## SEWAGE DISPOSAL SYSTEM

SUBDIVISION Fulton Manor East LOT 9 ROAD 12370 Pleasant View Drive

Re: Fulton Manor East, Lot 9  
Permit Amendment Request  
Permit # B00110050

**FULTON MANOR EAST, LOT 9 PLAT 12672 PLOT PLAN**

**LOT 9 SITE PLAN**  
 SCALE: 1" = 30'

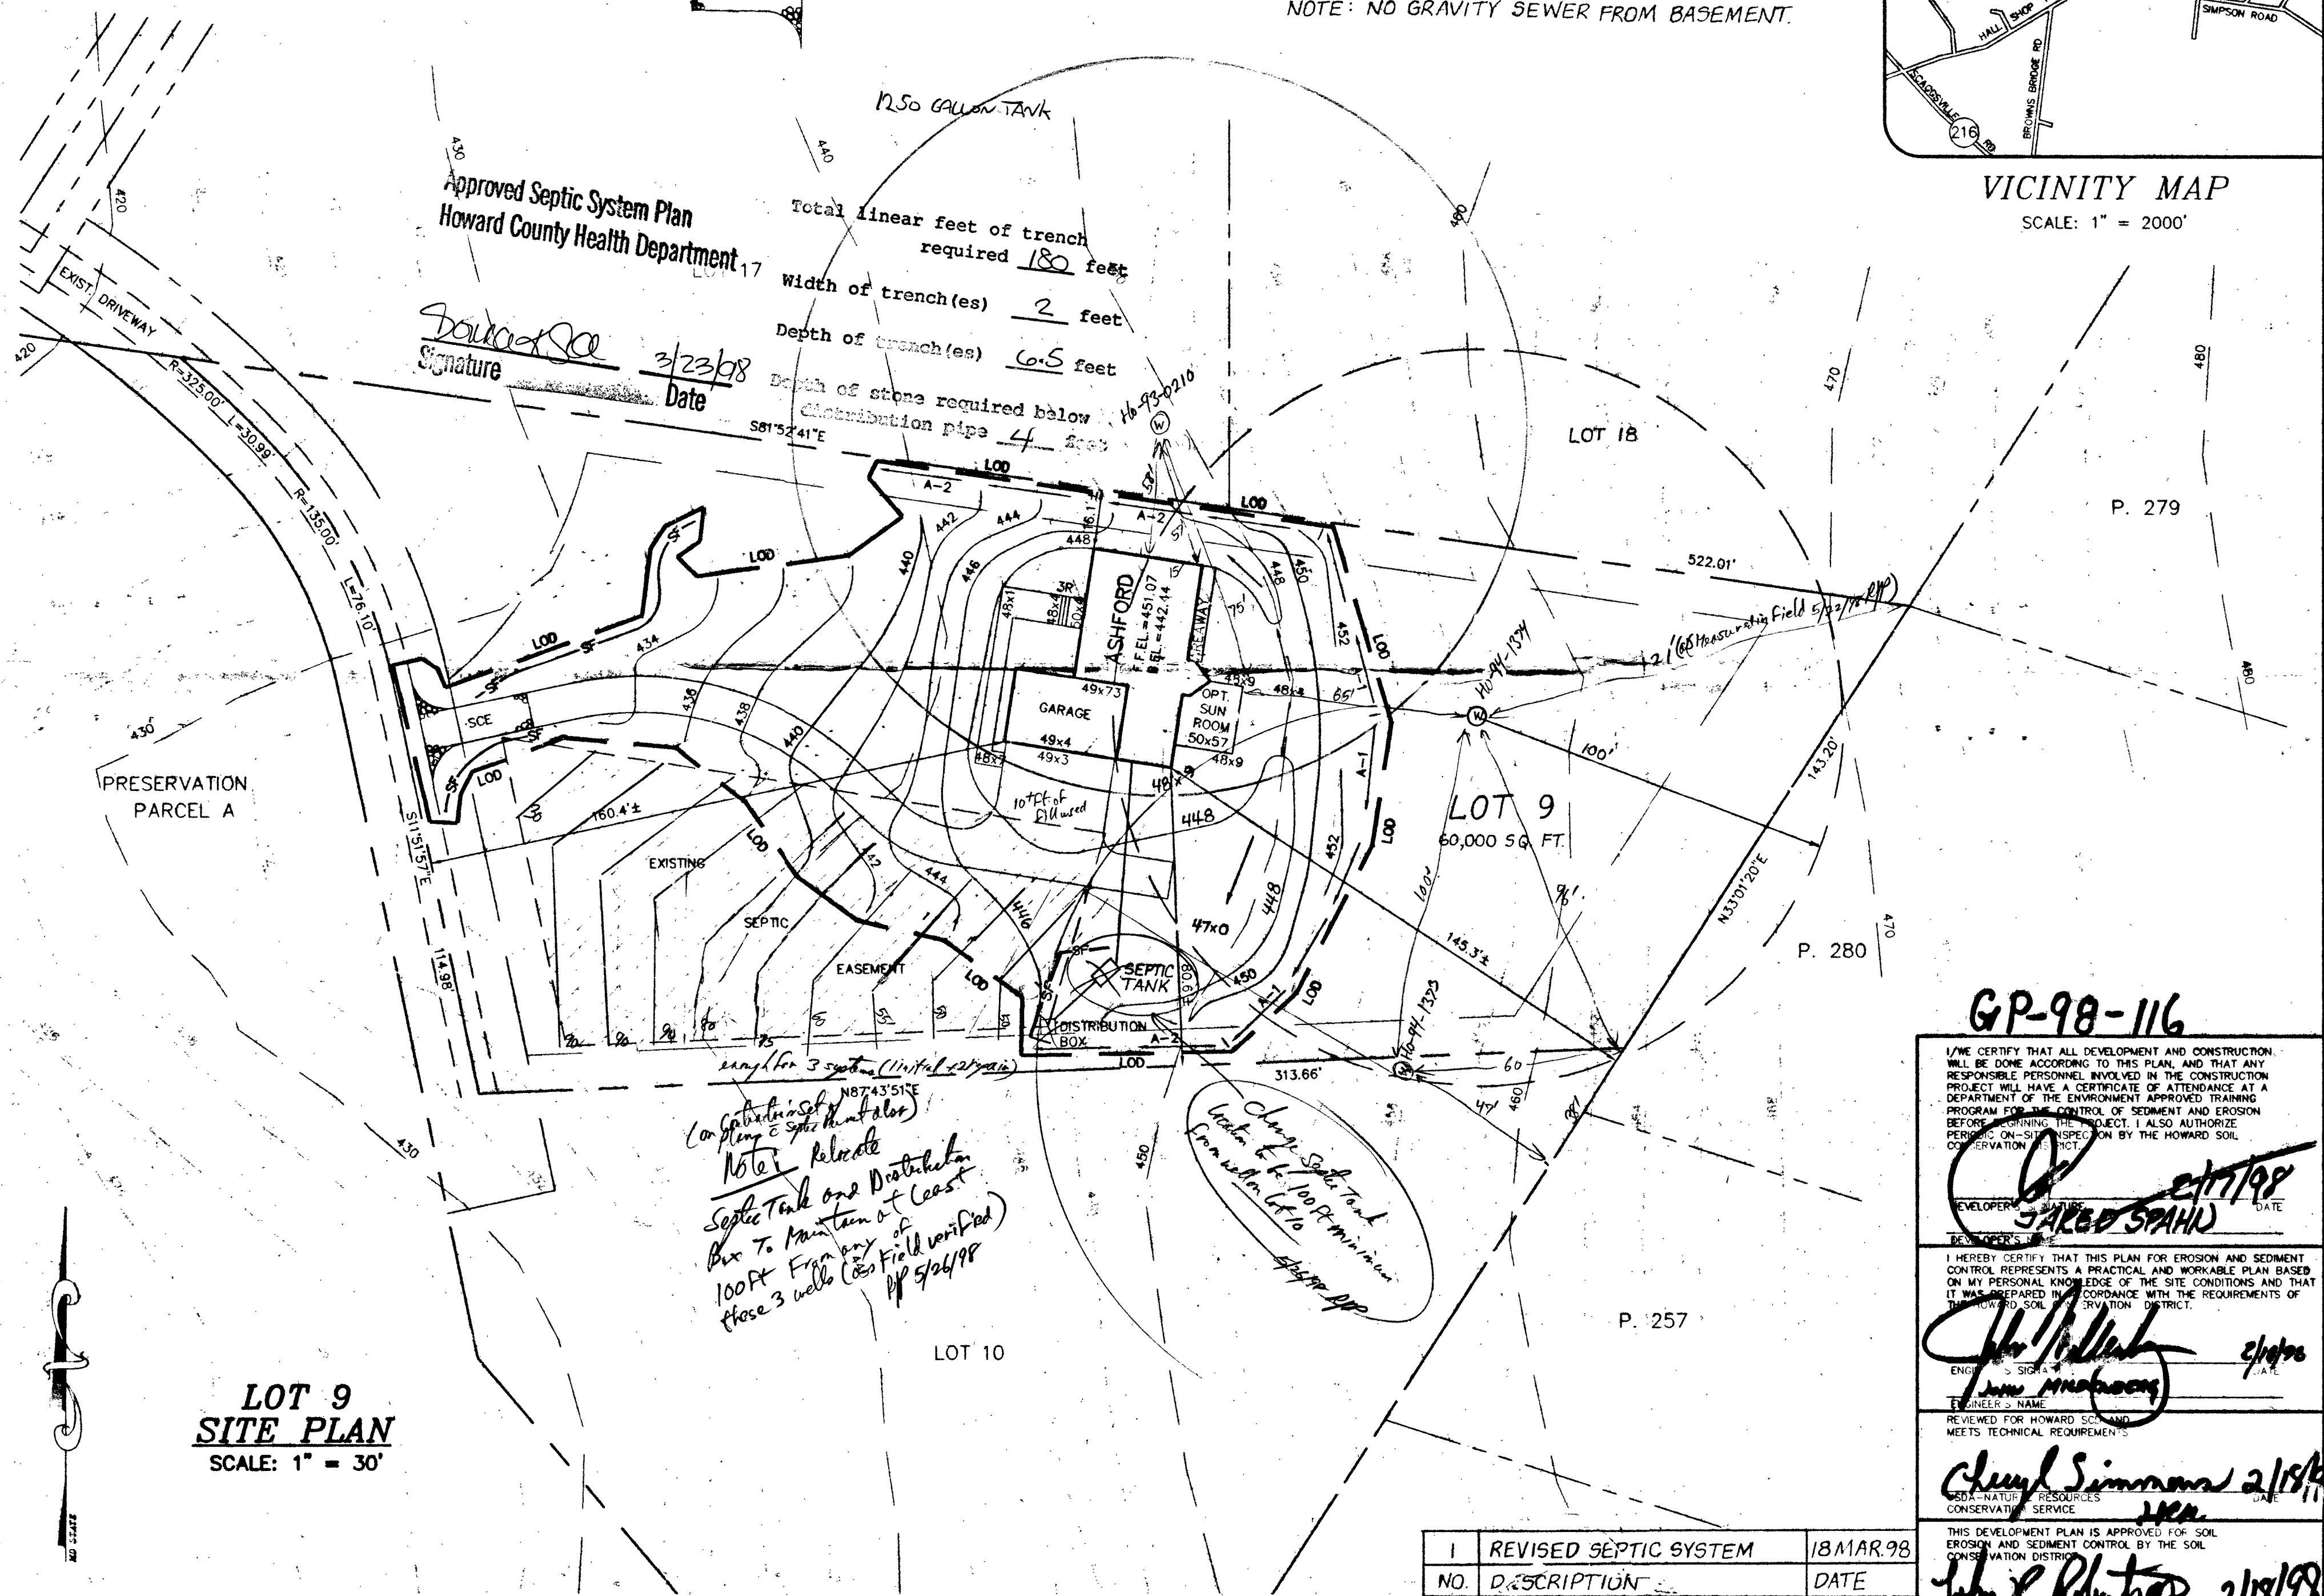
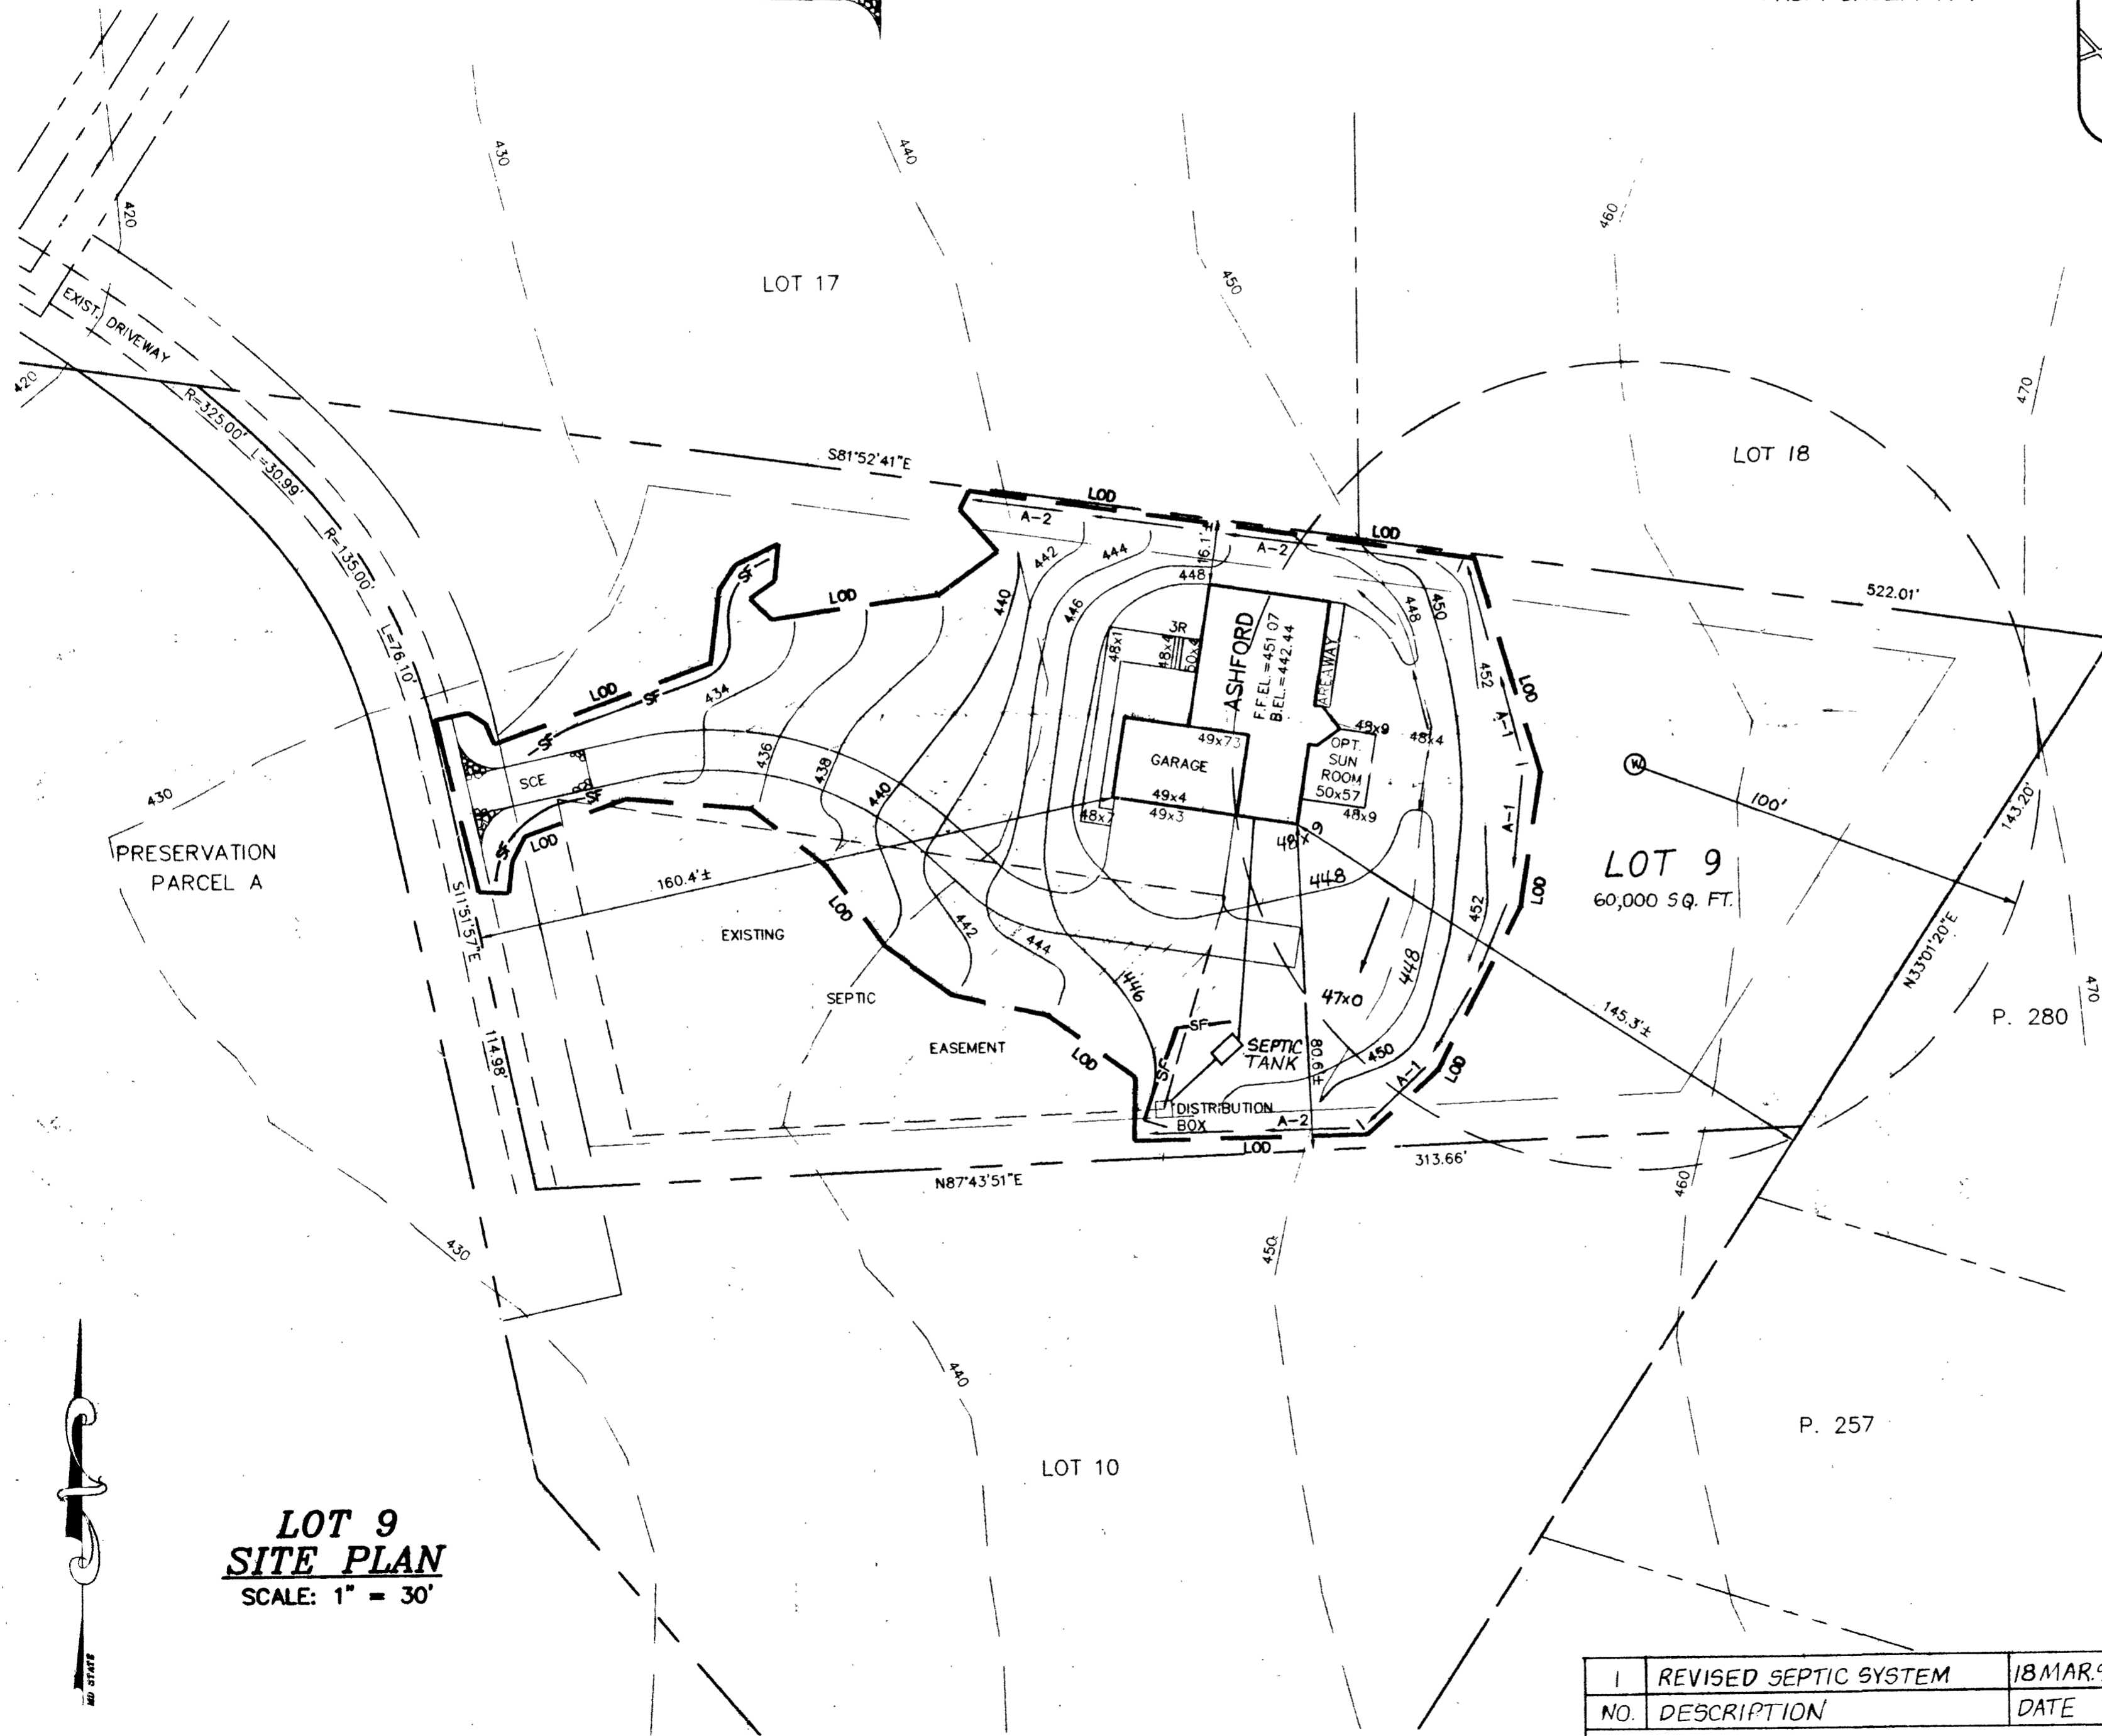
We have made a "plumbing change" on Sheet 1 of 2 of the plot plan for the above referenced lot as requested by Ms. Kim Soe of the Howard County Health Department. This change included raising the invert elevations of the proposed septic tank, and therefore the invert elevations of the associated gravity sewer house connection, per Ms. Soe's instructions. Raising the septic tank vertically also resulted in moving it approximately ten (10) feet horizontally, as well as shifting the 446-contour line to the west. These changes appear on the "Site Plan" near the eastern side of the septic easement, and in the elevation table just to the left of the "Vicinity Map". The note previously stating "Force main is required from pump pit to distribution box" has therefore been changed to read "No gravity sewer from basement".

Bo0110050  
 Bo0110074  
**REVISED**  
 Date: 3-19-98  
 Comments: *septic tank moved*  
**GP-98-116**

NOTE: NO GRAVITY SEWER FROM BASEMENT.

NOTE: NO GRAVITY SEWER FROM BASEMENT.

*3/30/98 Revised PP plan  
 period of approval  
 [Signature]*
